LOADLEASH: POTENTIAL OIL FITTING LEAKAGE

Cummins 6.7L ISB and Paccar PX-7 engines

FIGURE 1:

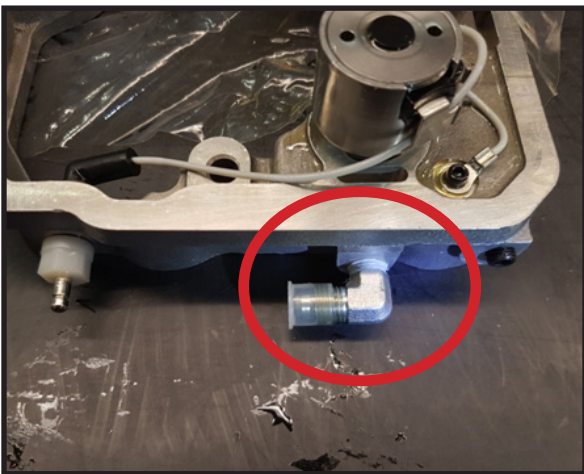
The 1/8" NPT fitting of the oil feed has a leakage potential due to improper installation.

Affected Oil Port 1/8" NPT fitting.

It is imperative to immediately inspect the LoadLeash housing for potential cracks / oil leaks at the oil feed port of the housing.

Inspection of this oil feed port does not require removal of the LoadLeash housing, inspection may be accomplished using a mirror or borescope.
